RE: Additional Comments from the Springbank Hill Community Association and Springborough Residents Regarding Application LOC2019-0162

We as a community have been asked to give our support to partners development LOC2019-0162. This application is scheduled to be reviewed at CPC on March 18 (CPC2021-0316 item 7.2.1).

PLAN EVOLUTION - CROSS SECTIONS

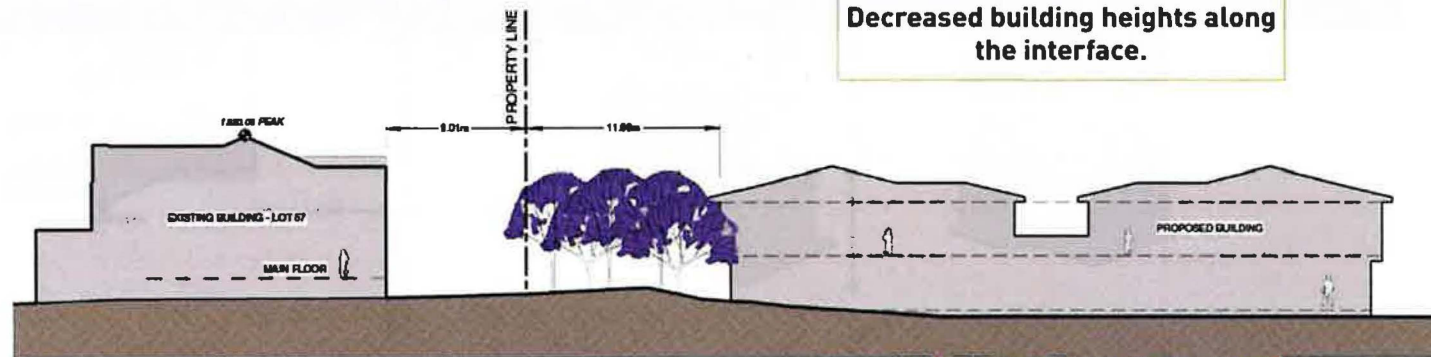
1. Density in 'site 2' to be restricted to 60uph. 60uph is over a 10% increase in what the applicant is currently showing in their concept plan noted as "final submission Feb 2021" and would provide flexibility for issues caused by grades.
2. Restrict heights on new buildings bordering existing low density residential on the eastern boundary of 'site 2' to no more than 13 metres above grade. In the applicant's concept plan noted as 'final submission Feb 2021' the

applicant shows two storey buildings which appear to be no more than 10 metres above grade. In our discussions with Planning, we understand that 13 metres would provide flexibility for any issues caused by grades.

Heights Allowed in Land Use
Possible at DP

Create Fishbowl With Existing
Low Density Homes
